# Work Order ID 82349

Item Name: Crosstube Aft

DRAWING NO. D412-664-243	TITLE CROSSTUBE ASSEMBLY (412 HI AFT)	REV. E	DART AEROSPACE LTD ENGINEERING ORDER		D.E.O. NO. D412-664-243-E-1	SHEET NO. SHEET 1 OF 2	SCALE NTS
DRAWN	CHECKED	MFG. APPR.	APPROVED	DE APPR.			
DATE 11.03.31	DATE 11/03/31	DATE 11.03.31	DATE 11/03/31	DATE 11-03-31

DRAWING NO. D412-664-243	TITLE CROSSTUBE ASS'Y (412 HI AFT)	REV. E	<b>DART AEROSPACE LTD ENGINEERING ORDER</b>		D.E.O. NO. D412-664-243-E-2	SHEET NO. SHEET 1 OF 1	SCALE NTS
DRAWN <i>92</i>	CHECKED <i>ASS</i>	MFG. APPR. <i>ER</i>	APPROVED <i>MP</i>		DE APPR. <i>#</i>		
DATE 11.09.07	DATE 11.09.19	DATE 11.09.19	DATE 11.09.19		DATE 11.09.19

**D412-664-603** 10  
**BENDING AND DRILLING DETAIL** E

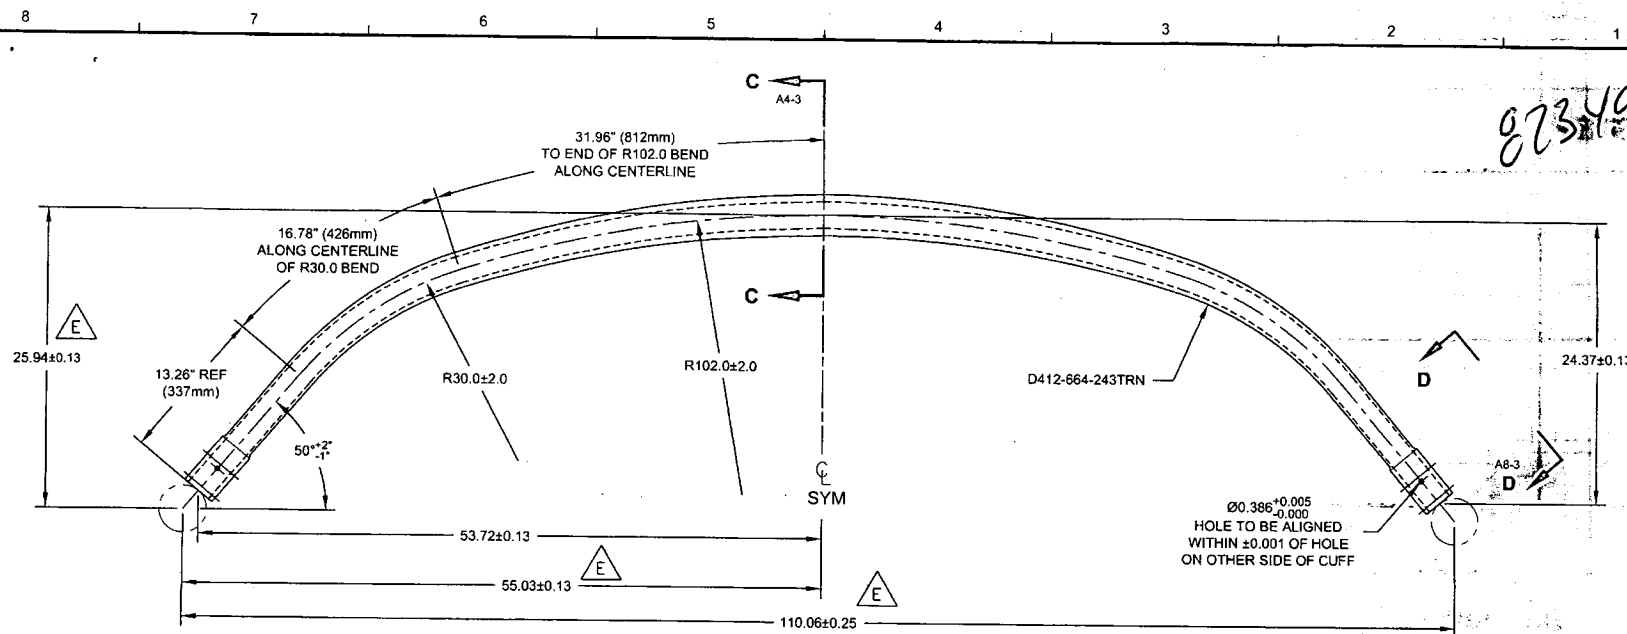
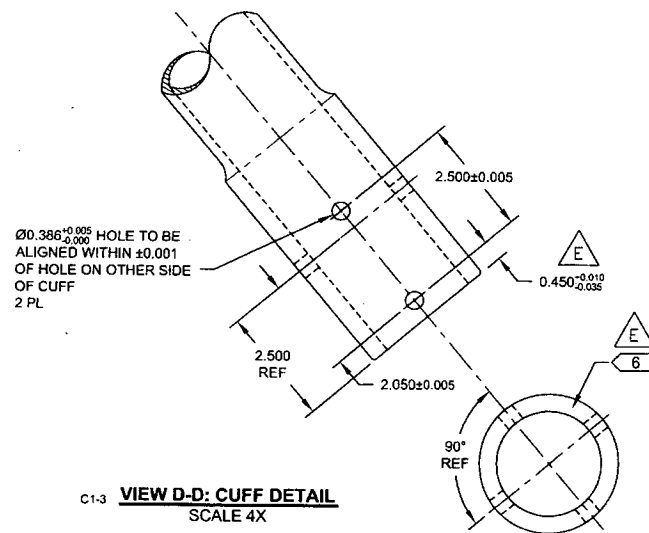
**PURPOSE:**

REMOVED ABRASION STRIP IN FAVOR OF A THIN LAYER OF PROSEAL 890.

NOTES 2 AND 14, SHEET 1 ARE AMENDED AS FOLLOWS:

**IS:**

D3189-1 CHAFING SHIELD (1, INSTALLED OVER PROSEAL 890)  
MS21920-28 CLAMP, 2X  
2 PL

D412-664-603  
BENT TUBE

MASK AREA PRIOR TO PAINTING AND  
APPLY CLEAR COAT AFTER PAINTING
